Response to September 14, 2006 Comments
Countryside Executive Golf Course
2506 Countryside Boulevard
Clearwater, Florida
HSA Project Number 601-5982-00

Subject: **Response to September 14, 2006 FDEP Comments**
Countryside Executive Golf Course
2506 Countryside Blvd.
Clearwater, Florida
HSA Project Number 601-5982-00

JOB NO.:	601598200
DATE:	10/3/06
CAD NO.:	598200-04
DESIGNED	N/A
DRAWN	SBW
CHECKED	BM
SHEET TITLE SOIL ARSENIC CONCENTRATIONS (2'-4')	
FIGURE 4

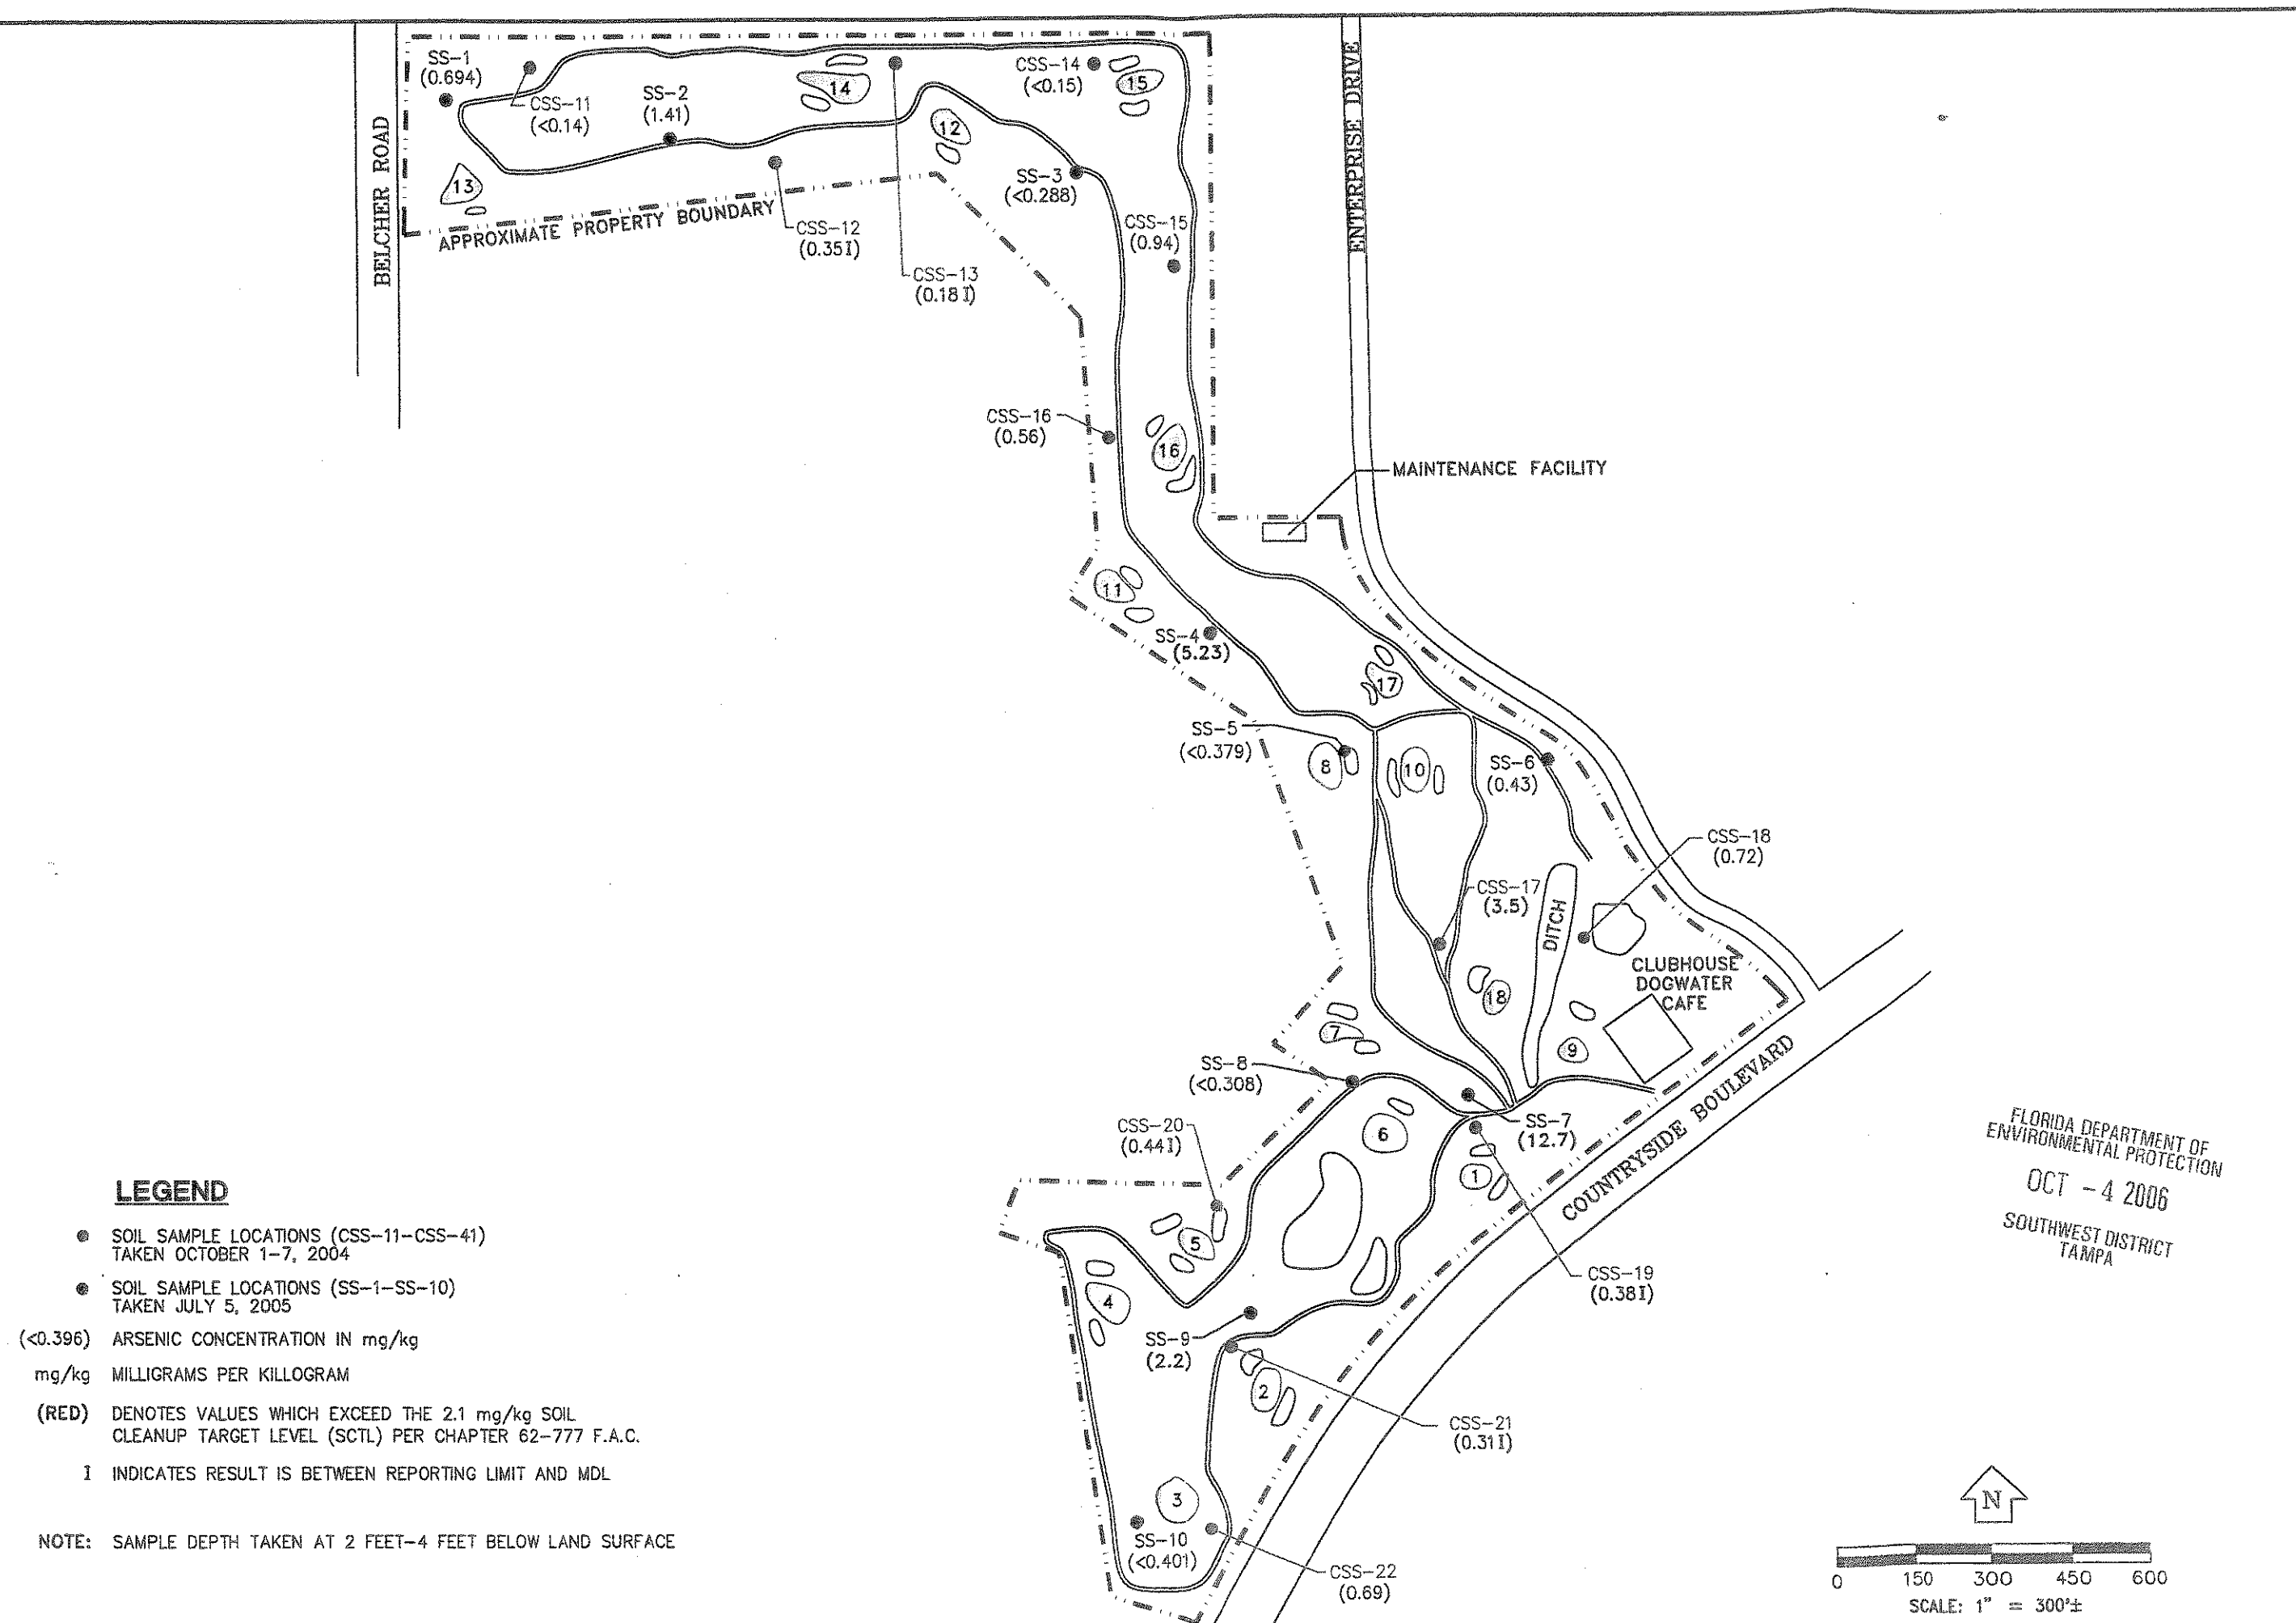
Comment 1: *Soil isoconcentration maps of arsenic by depth are needed to indicate where the site has been delineated.*

included under Chapter 62-780, Florida Administrative Code (FAC), soil arsenic impacts were evaluated for depths ranging from land surface to 6-inches bls (Figure 2), 6-inches to 2 feet bls (Figure 3), 2 to 4 ft bls (Figure 4), and 4 to 6 ft bls (Figure 5). The depth to groundwater across the site is approximately 4 to 6 ft bls.
